*PLANS FOR THE CONSTRUCTION OF
SEDIMENT REMOVAL
FOR
VITRUVIAN PARK
TOWN OF ADDISON, TEXAS
PUBLIC WORKS #19-77*

VITRUVIAN PARK
 DREDGING
 TOWN OF ADDISON
 DALLAS COUNTY, TEXAS

revisions	date
1 ADDENDUM 3	2/20/2019

DEWATERING AND STORAGE LOCATION
 STA. 0+00 TO STA. 3+20

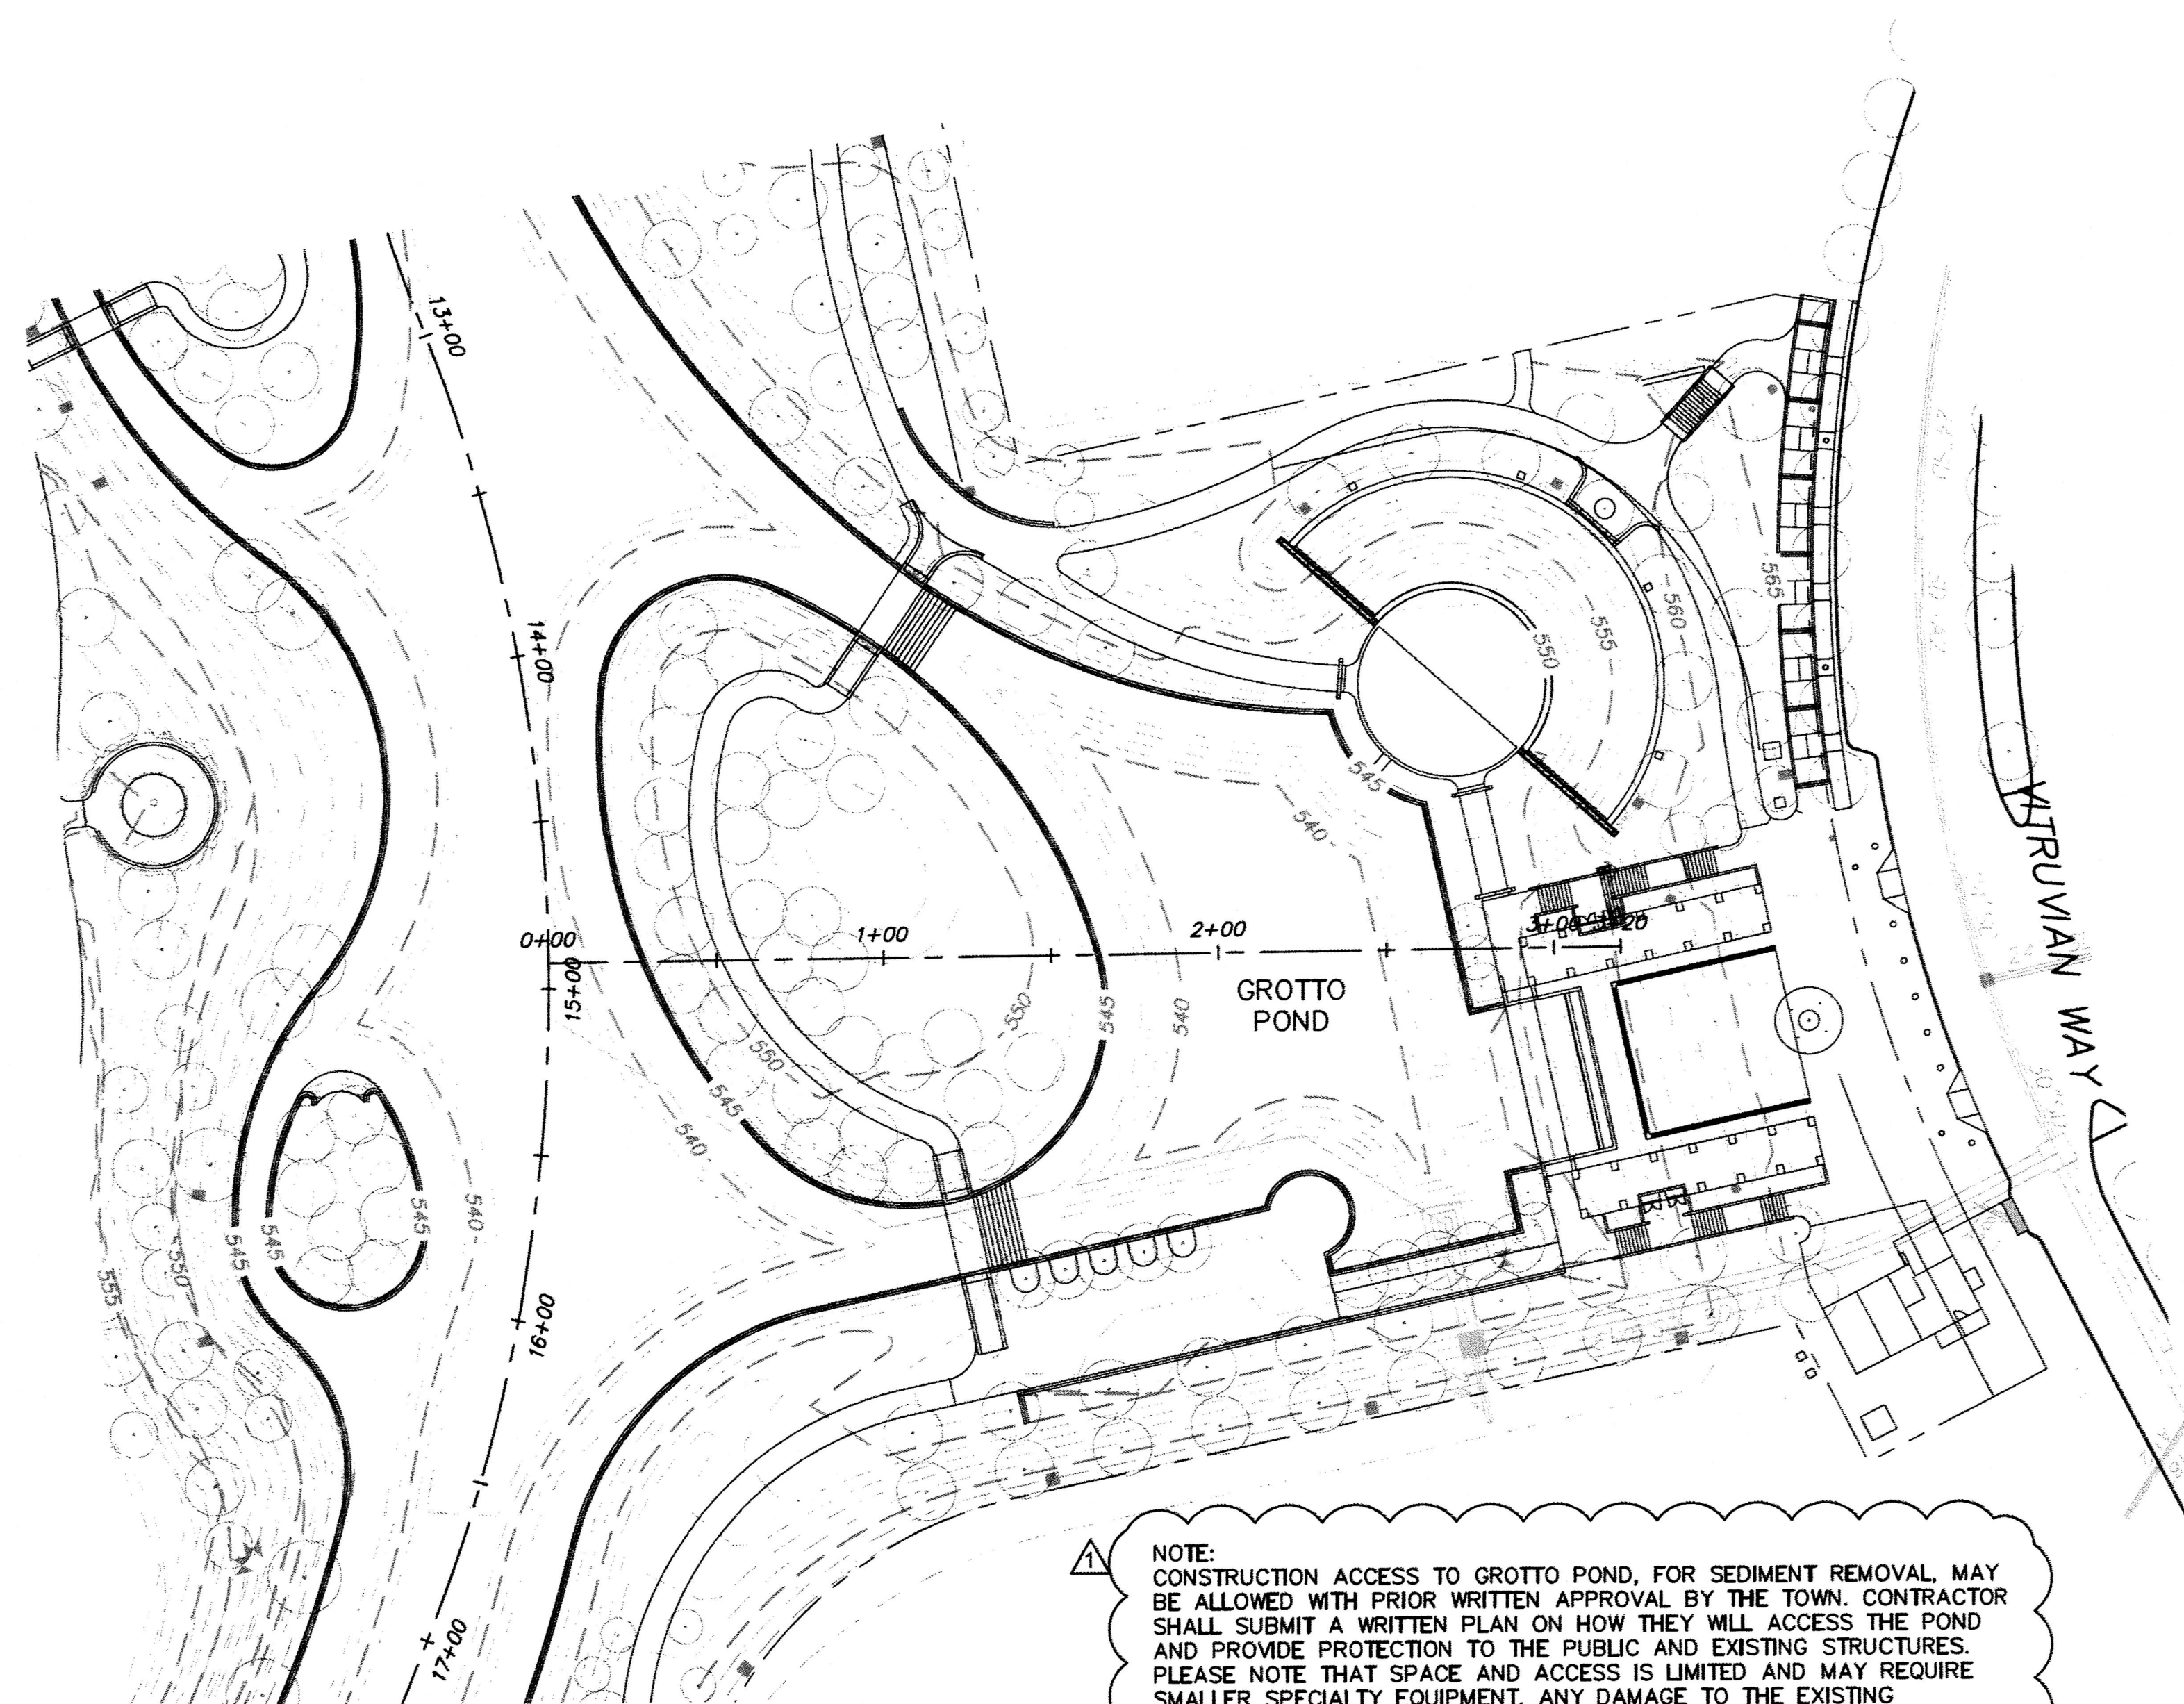
NOTE:
 CONSTRUCTION ACCESS TO GROTTO POND, FOR SEDIMENT REMOVAL, MAY BE ALLOWED WITH PRIOR WRITTEN APPROVAL BY THE TOWN. CONTRACTOR SHALL SUBMIT A WRITTEN PLAN ON HOW THEY WILL ACCESS THE POND AND PROVIDE PROTECTION TO THE PUBLIC AND EXISTING STRUCTURES. PLEASE NOTE THAT SPACE AND ACCESS IS LIMITED AND MAY REQUIRE SMALLER SPECIALTY EQUIPMENT. ANY DAMAGE TO THE EXISTING STRUCTURES THAT OCCURS AS A RESULT OF THE CONTRACTOR'S ACTIONS IS TO BE REPLACED AT THE CONTRACTOR'S EXPENSE.

MAIN CHANNEL CROSS SECTIONS				
design	drawn	checked	scale	date
NDM	NDM	NDM	NDM	2/20/19

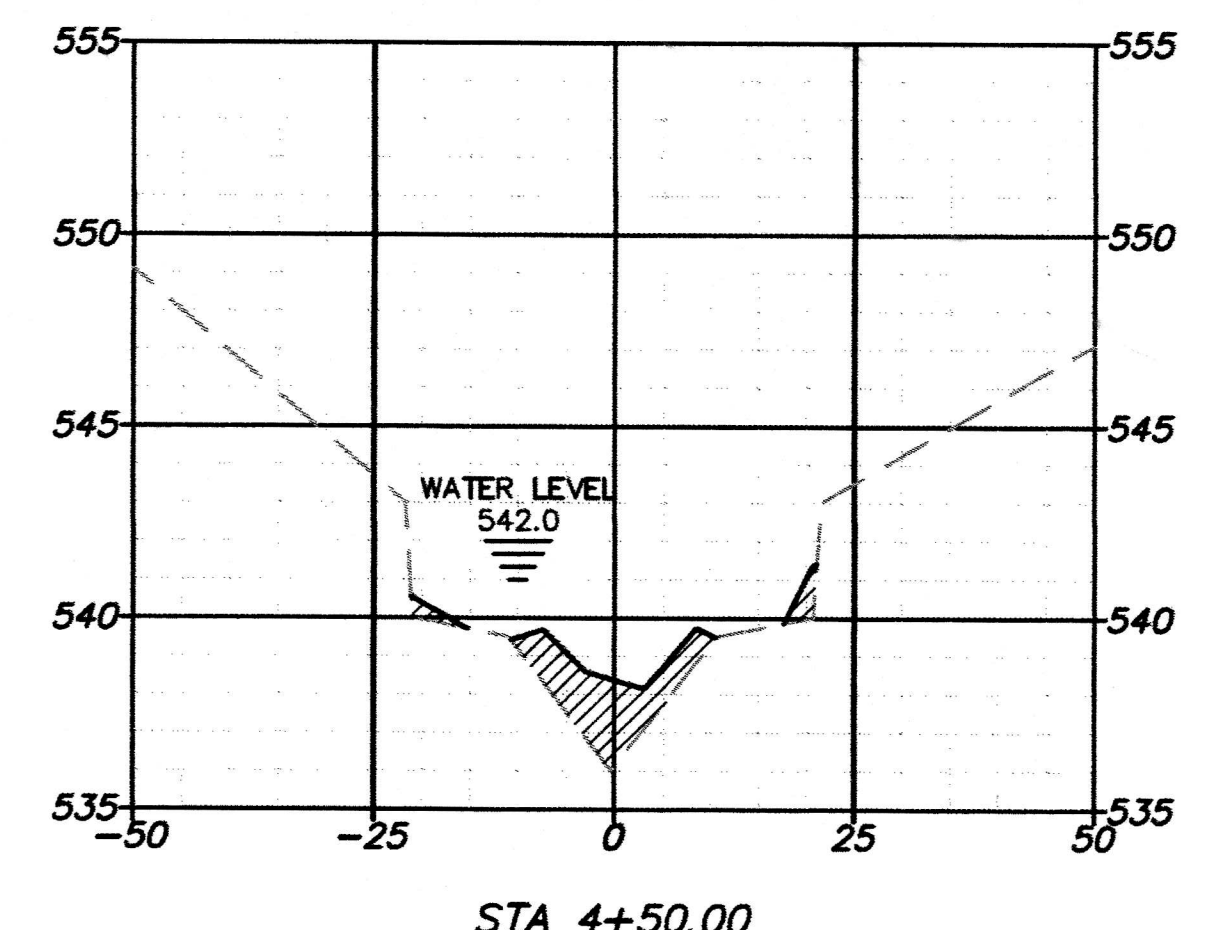
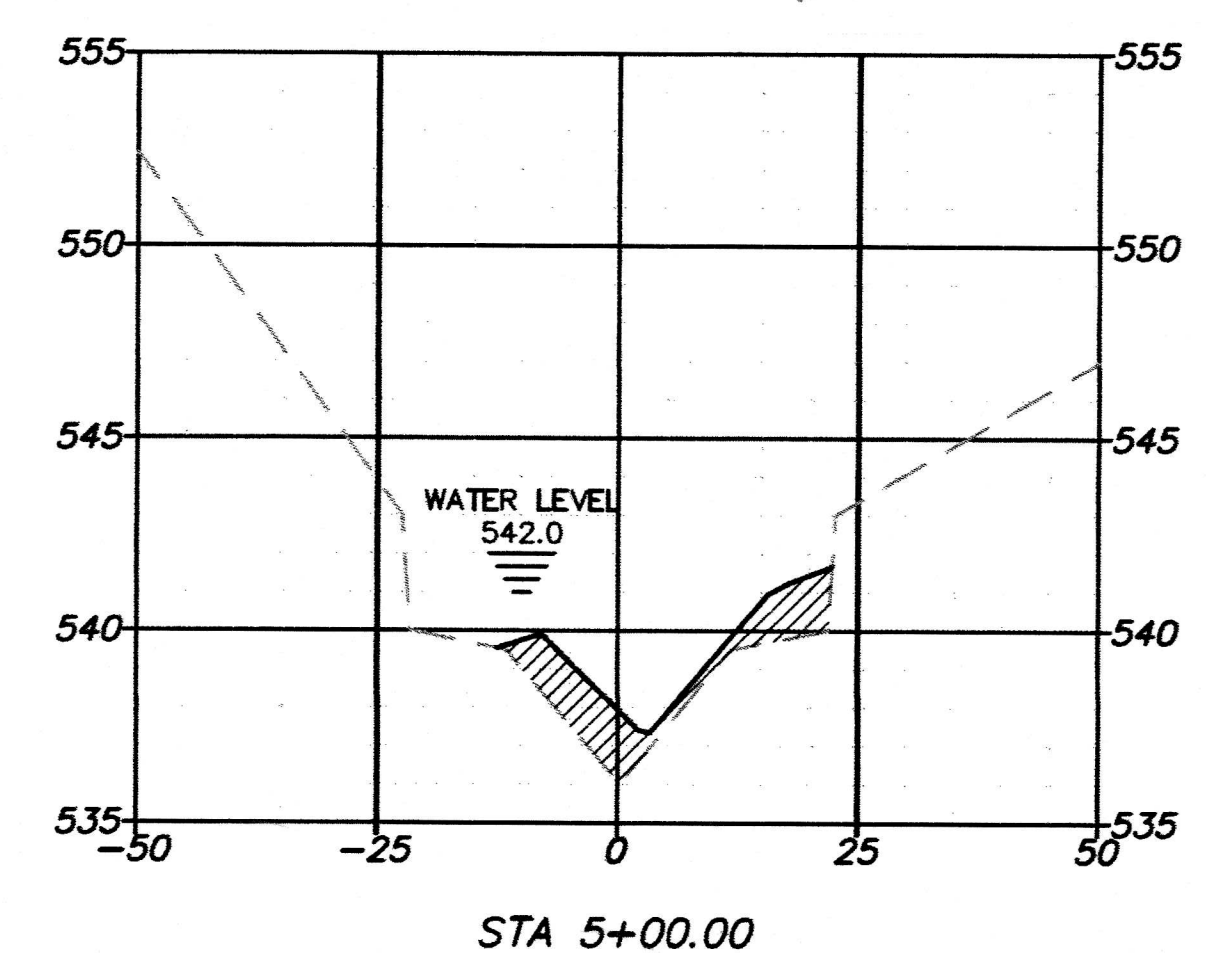
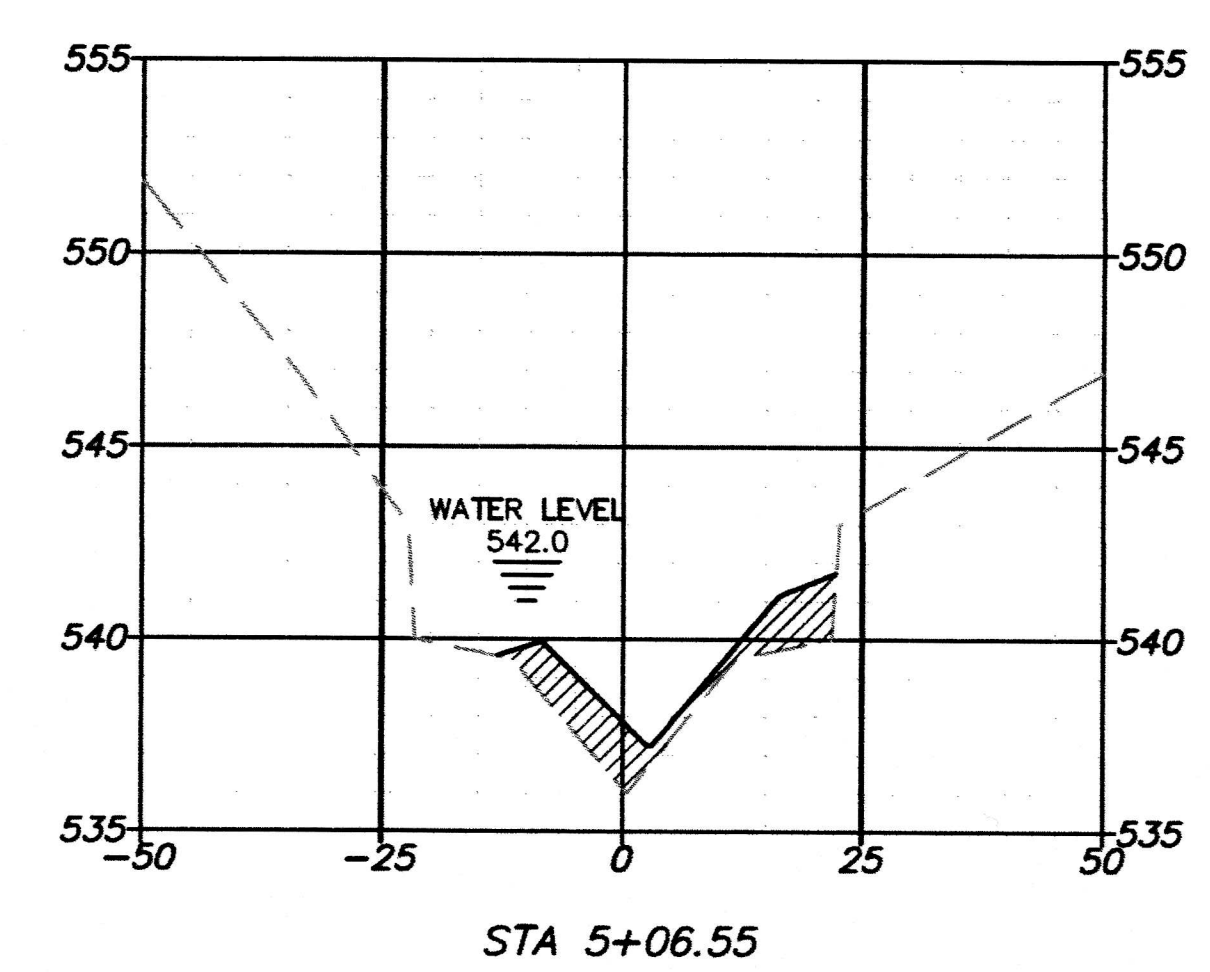
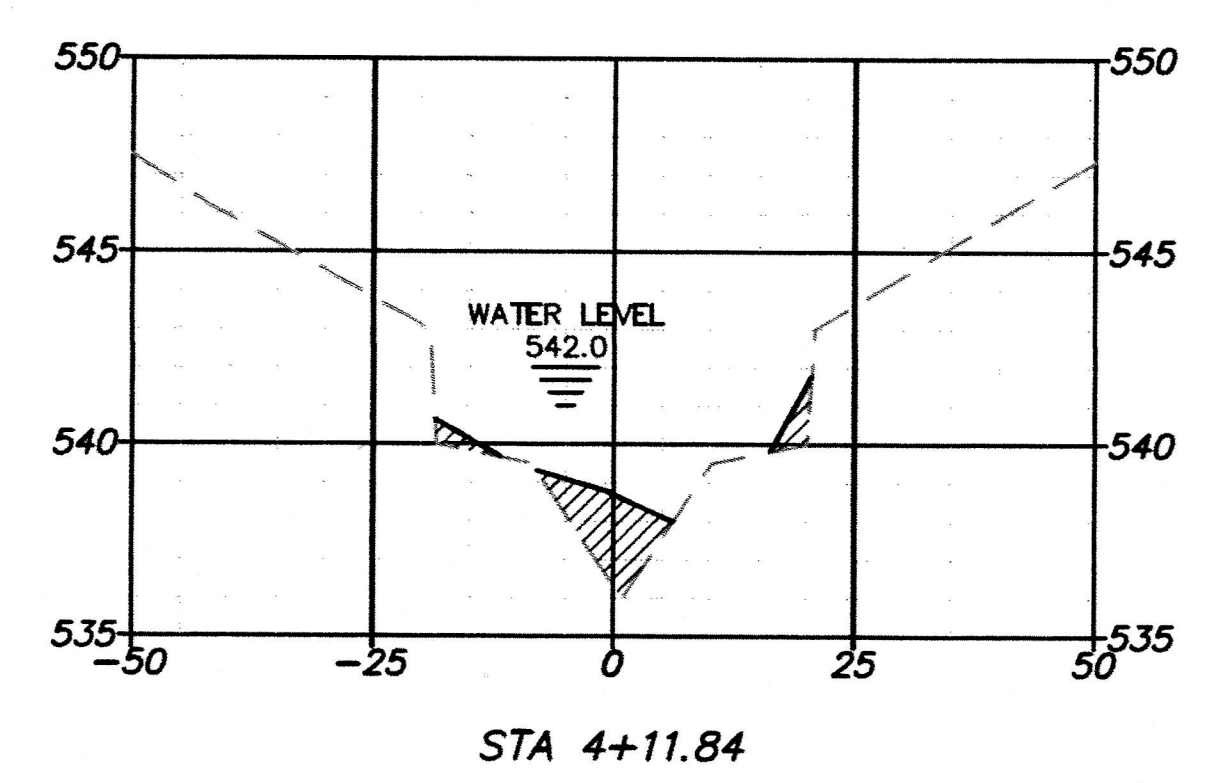
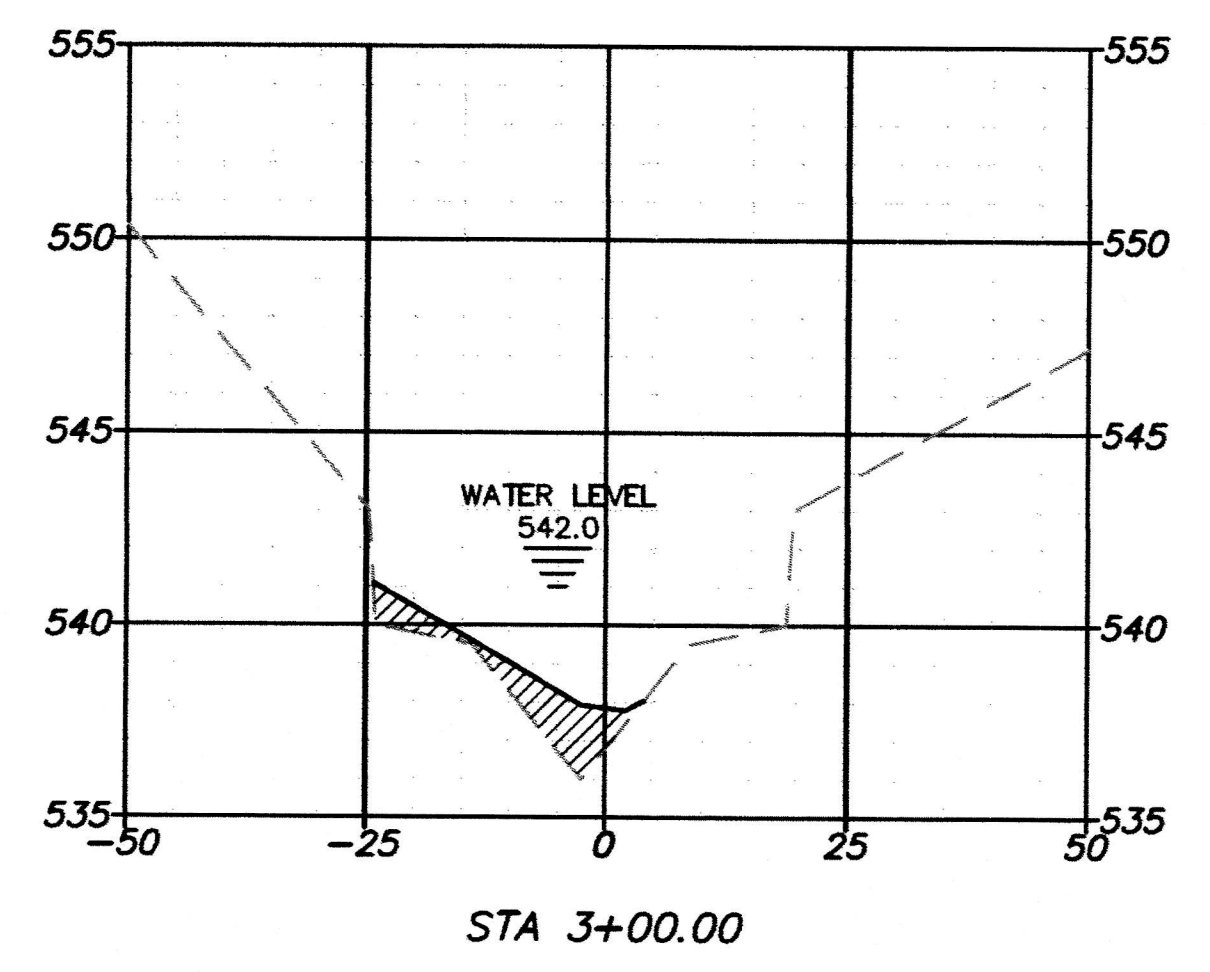
▲ WATER SURFACE ADDED BASED ON SURVEY OF 2/18/2019.
